HISTORIC AND DESIGN REVIEW COMMISSION

HDRC CASE NO: 2018-383
ADDRESS: 318 W HOUSTON ST
LEGAL DESCRIPTION: NCB 105 BLK LOT 21 (ALAMEDA THEATER SUBD)
ZONING: D, HE
CITY COUNCIL DIST.: 1
LANDMARK: Alameda Theater Interior
APPLICANT: Michael Ray/Overland Partners
OWNER: City of San Antonio
TYPE OF WORK: Construction of a rear addition
APPLICATION RECEIVED: September 28, 2018
60-DAY REVIEW: November 27, 2018
REQUEST:

The applicant is requesting conceptual approval to construct an addition atop of the existing addition at the rear of the Alameda Theater. The existing addition that will be constructed atop of was constructed in 2012.

SIGNAGE DETAILS

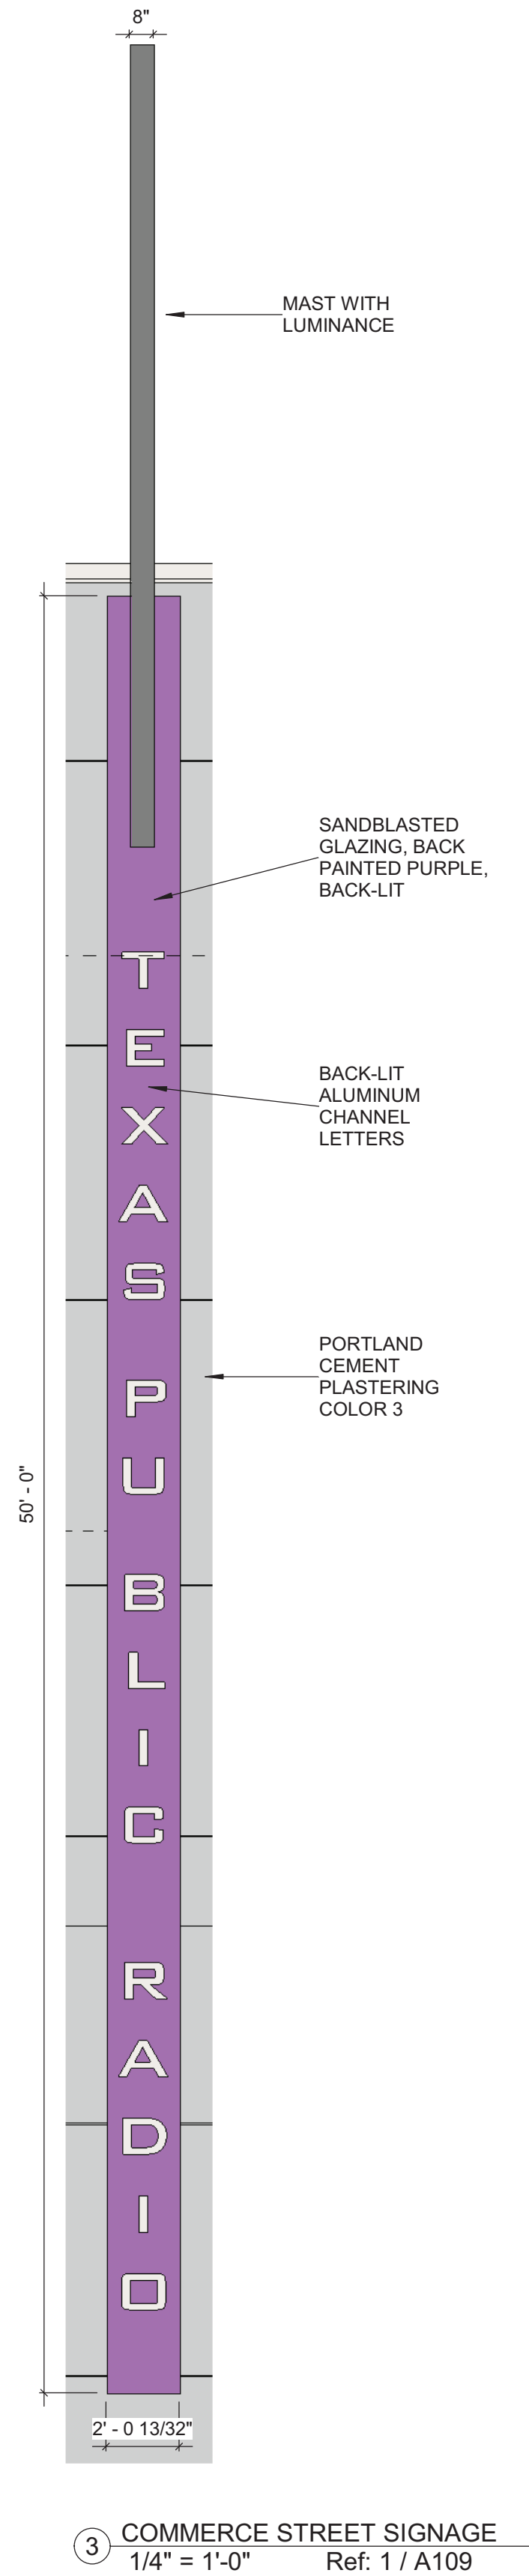
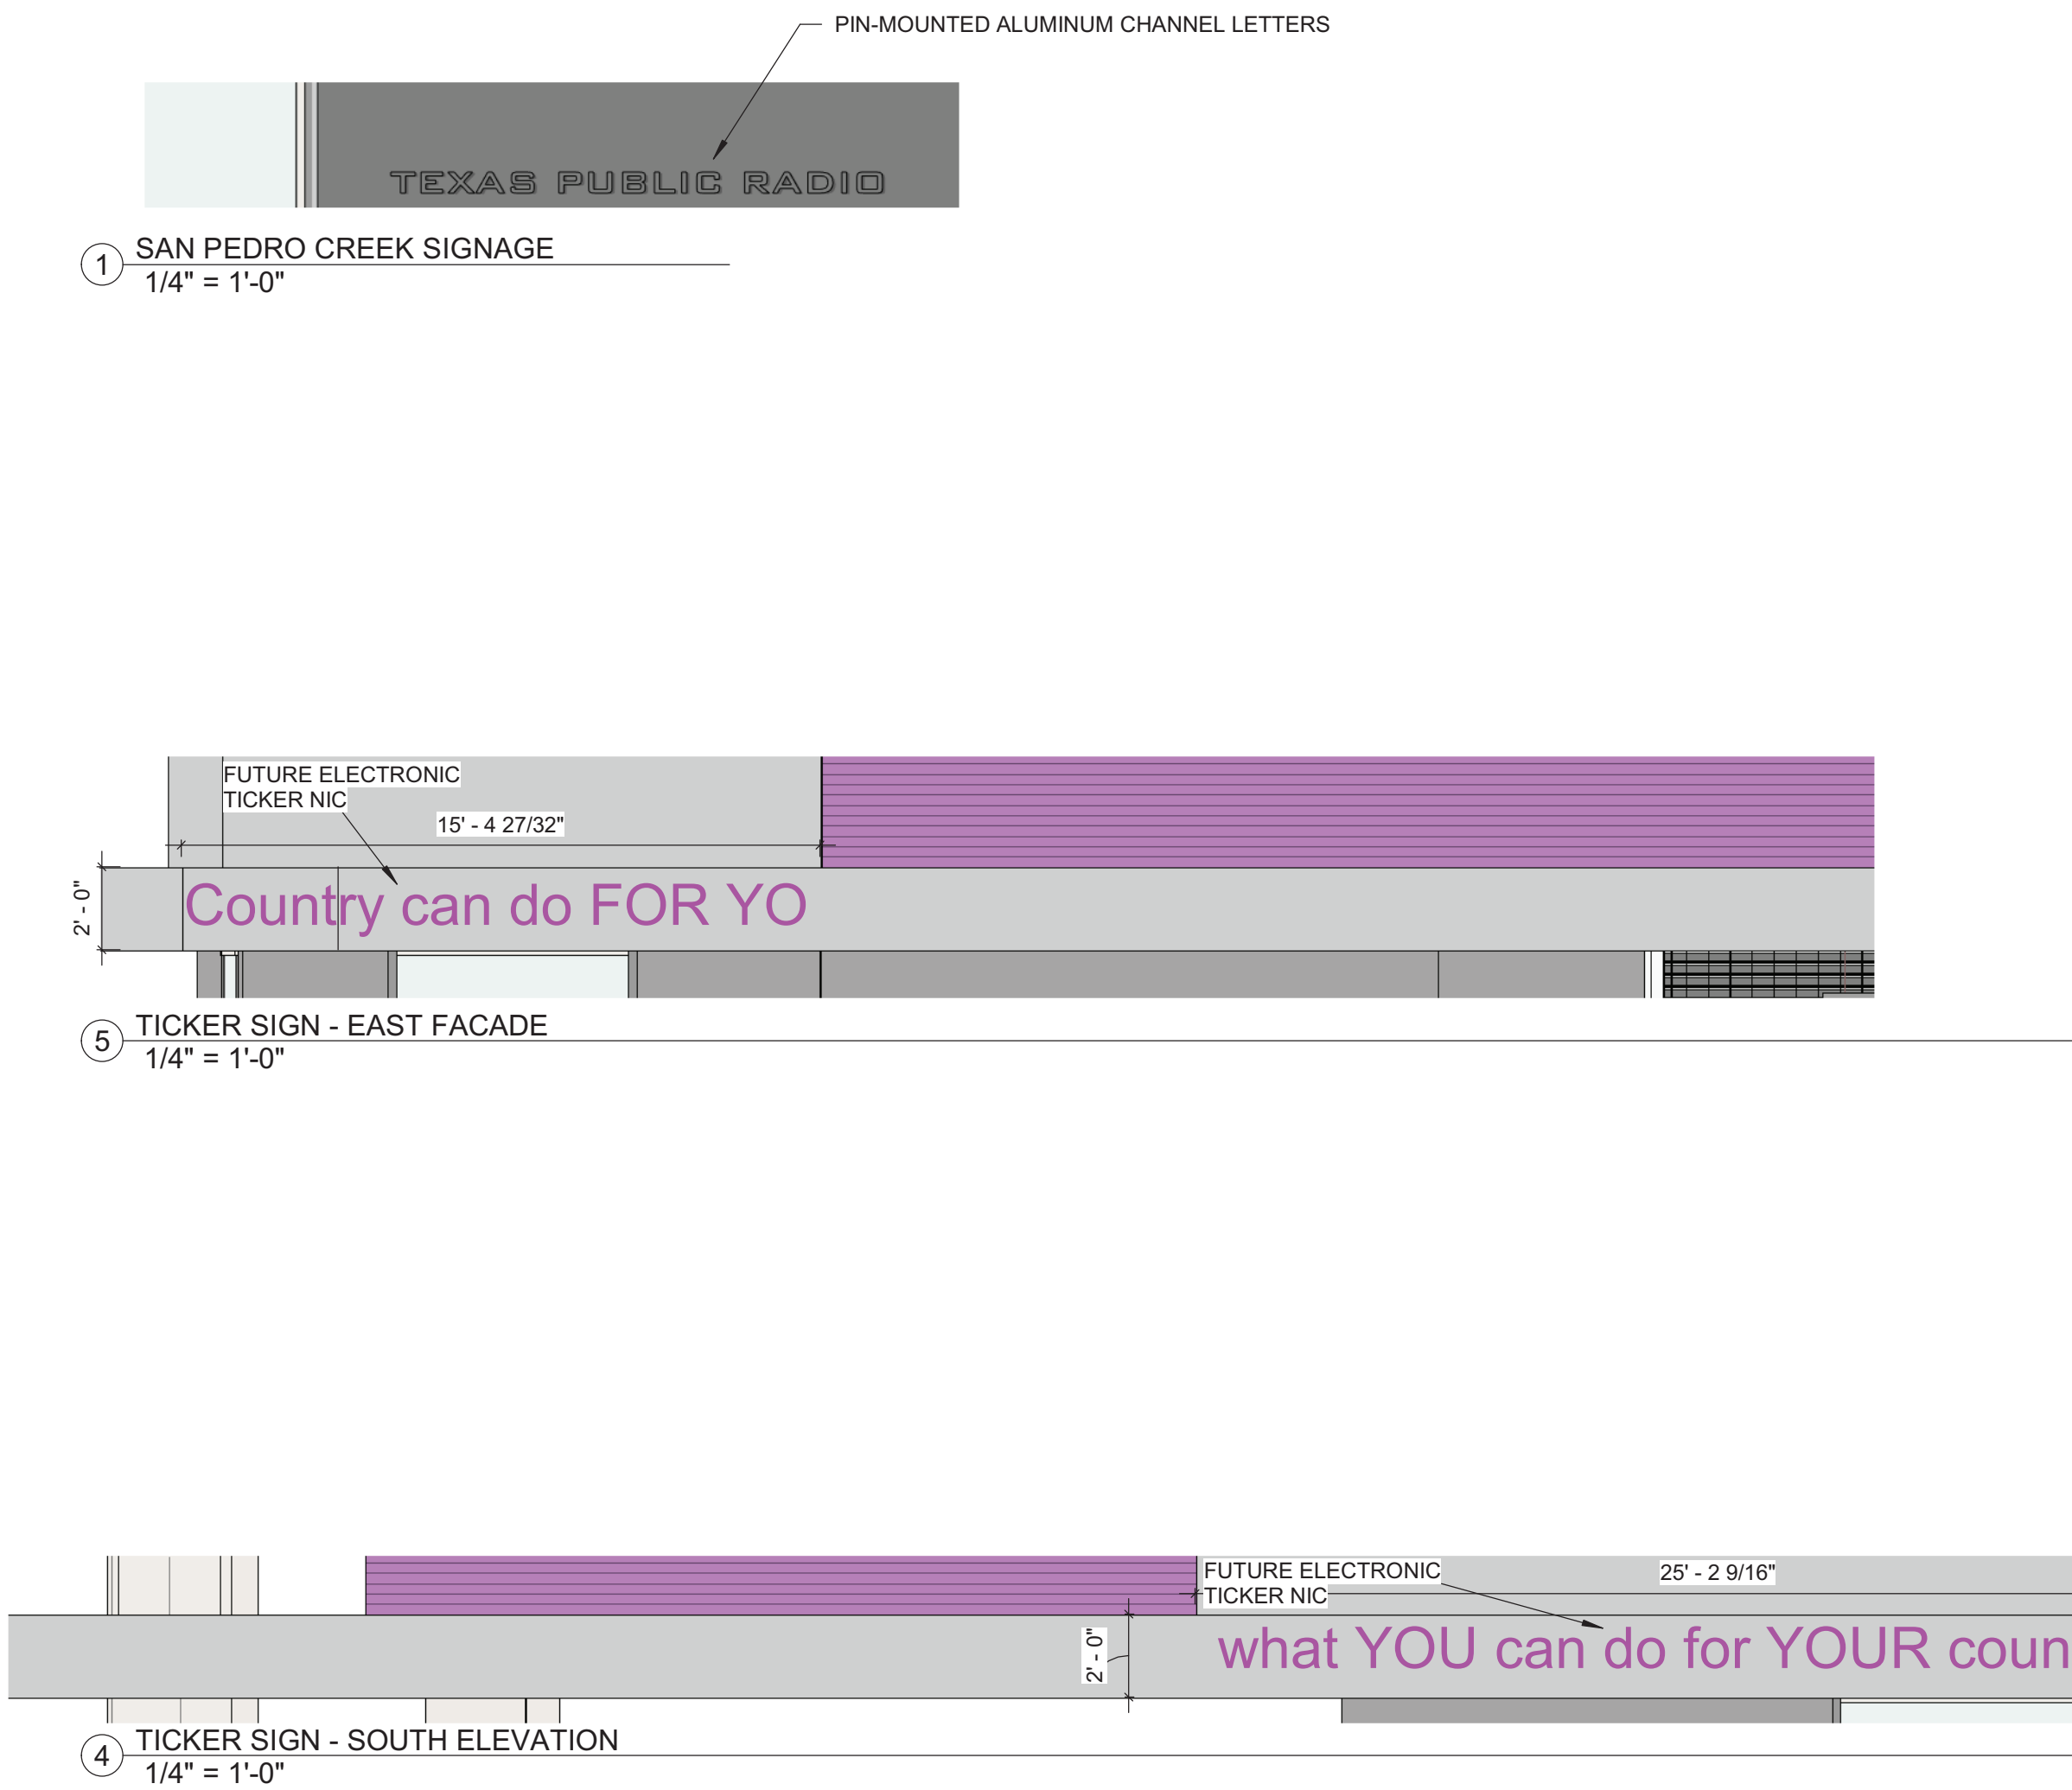
- n. **SIGNAGE (Channel letters)** – The applicant has noted the installation of reverse lit channel letters at two locations; on the south façade and on the east façade, both facing San Pedro Creek. The applicant has noted that both locations will feature backlit, aluminum channel letters. Staff finds the proposed signage locations, scale, materials and lighting to be appropriate. Signage specifications that are consistent with what is noted in the

- p. SIGNAGE TICKER – The applicant has proposed a digital news ticker to be installed on both the south and east elevations at the pedestrian level. While digital signage is typically discouraged for properties abutting the river or creek, this specific type of digital display may also be allowed under the provision cited above provided that the content does not include advertising or promotional messages. Specific requirements and potential approval of a specific use authorization by City Council will be identified by staff prior to the issuance of a Certificate of Occupancy.

submittal may be submitted to OHP staff for administrative approval.
